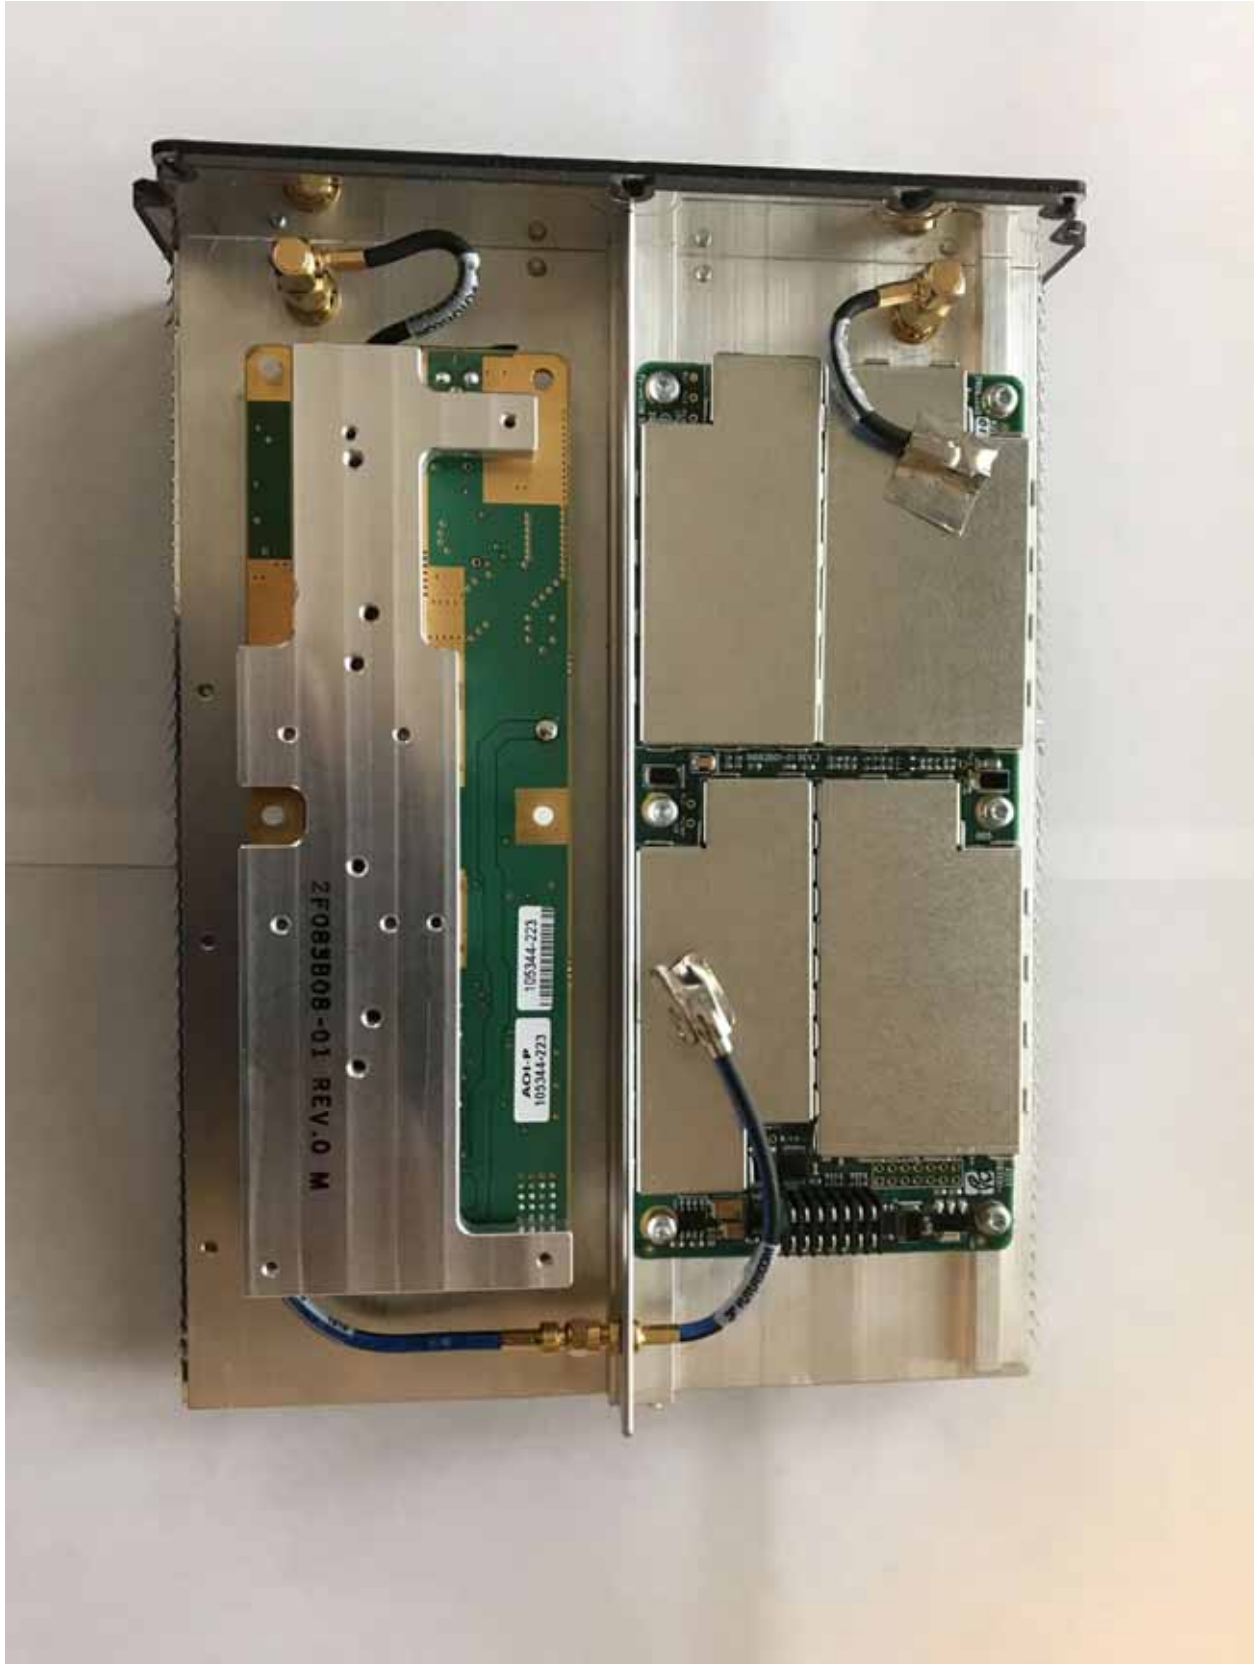
Foil was added on the EMI gasket

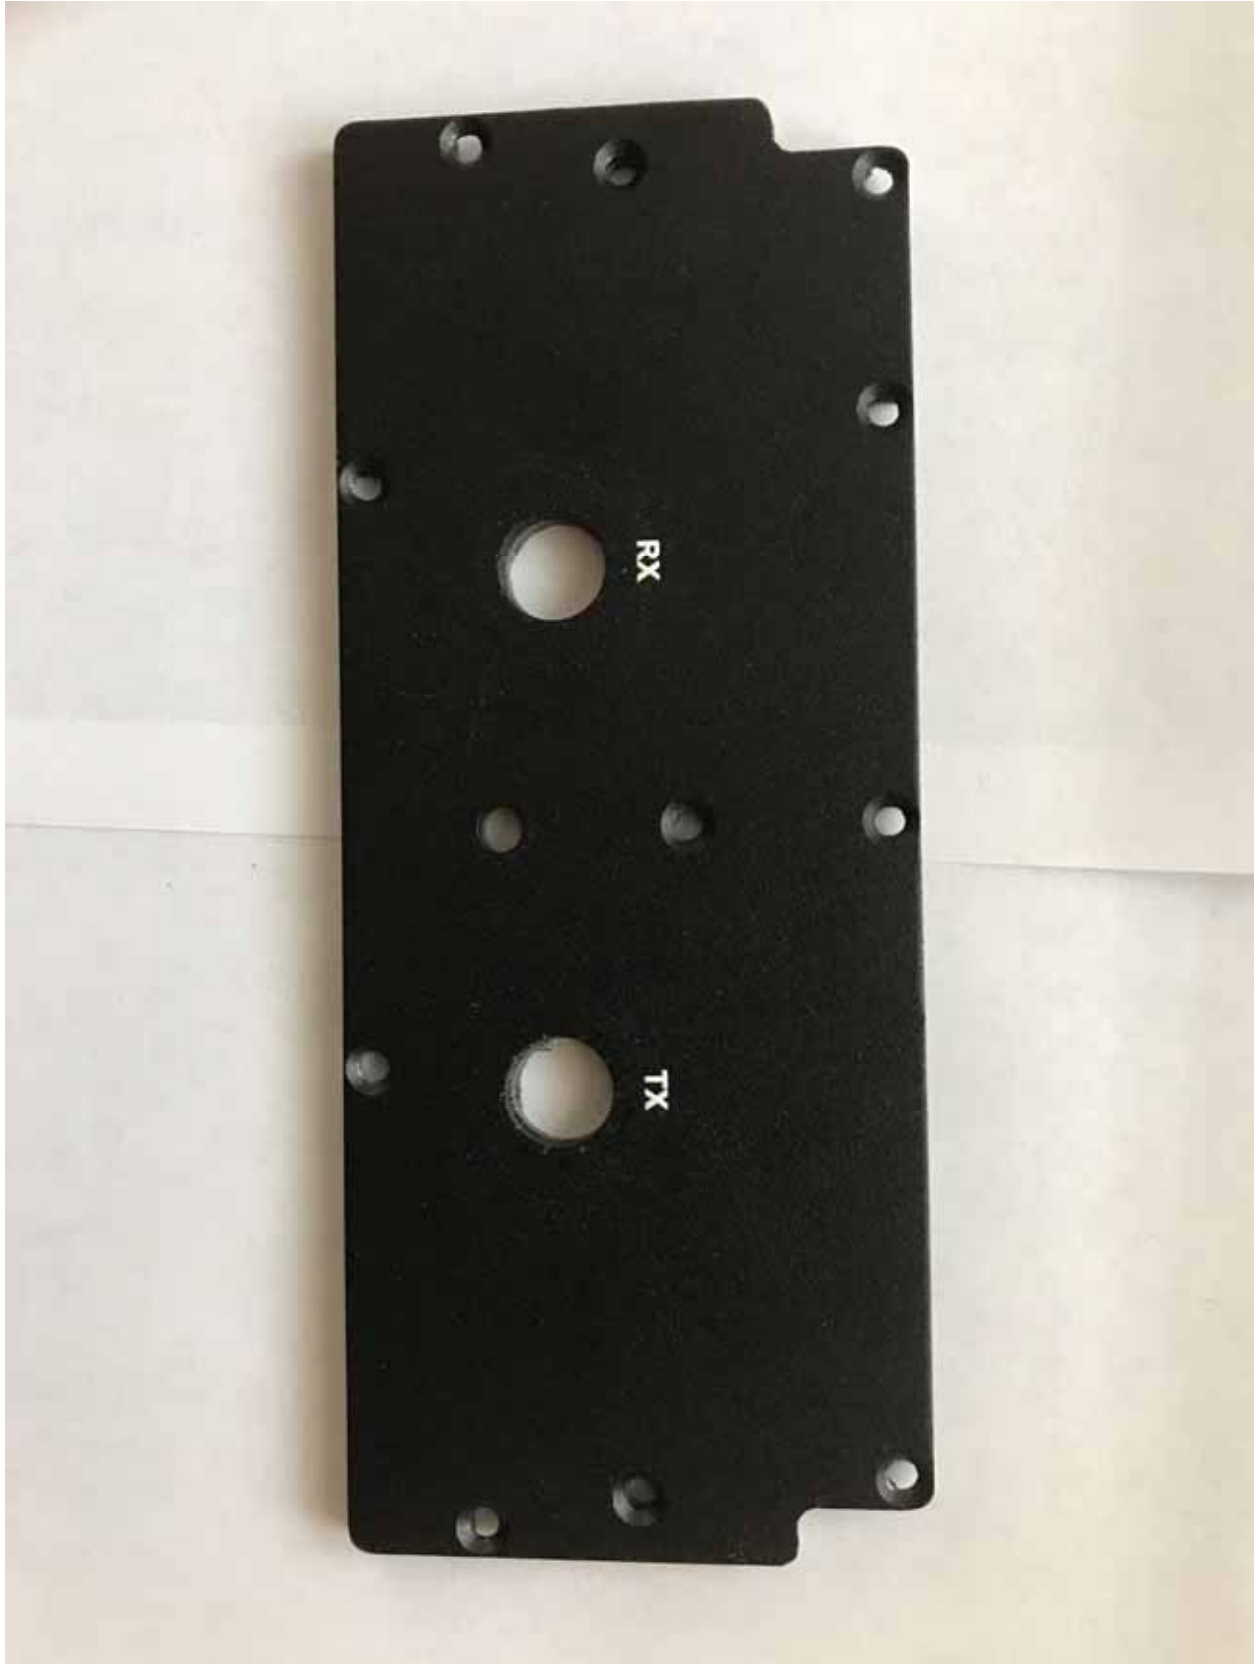
The cover is 4mm larger and a screw was added in the upper left corner.
The cover now displays DVR-LX.

Finger stock was added on both long partition edges.

Finger stock was added on both long partition edges.

The cover is 4mm larger and the upper right screw was added

New TNC connectors.

New TNC connectors.
